**STATE OF NORTH CAROLINA
UTILITIES COMMISSION
RALEIGH**

DOCKET NO. E-100, SUB 179

**TECH CUSTOMERS' COMMENTS
ON PROPOSED CARBON PLAN**

Figure 3-4: Capacity Mix by Portfolio, Combined Carolinas System (GW basis)

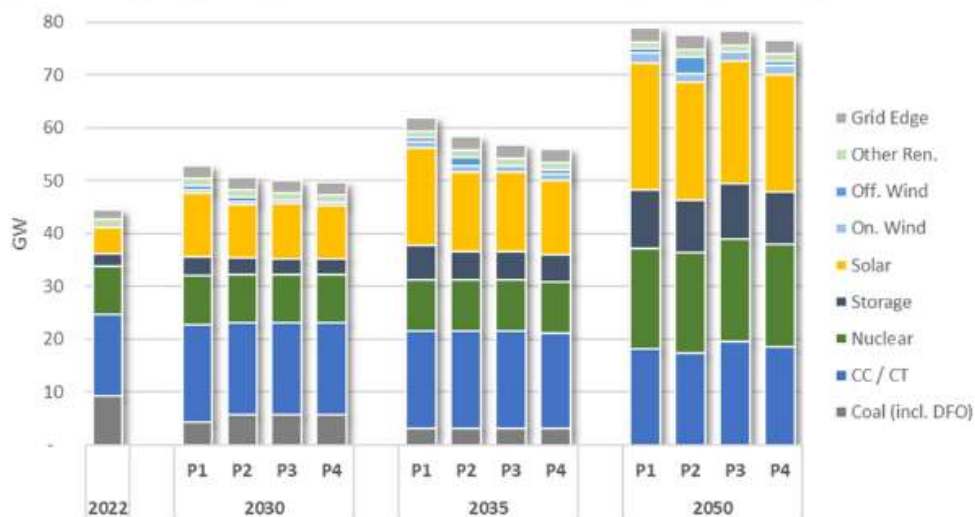
Duke’s proposed Carbon Plan is four modest variations on a single pathway forward, each reliant on new and unproven technologies. Rather than explore alternative solutions for achieving carbon neutrality, the four Portfolios converge on essentially the same generation stack by 2050, as illustrated by Duke’s Figure 3-4⁴:

As is clear from Figure 3-4, each of Duke’s modeled portfolios pull nearly 25% of their generation capacity from CCs/CTs (to be converted to hydrogen) and a near-doubling of nuclear capacity from advanced nuclear generation—with both resources being dependent on future technological evolution and market development.
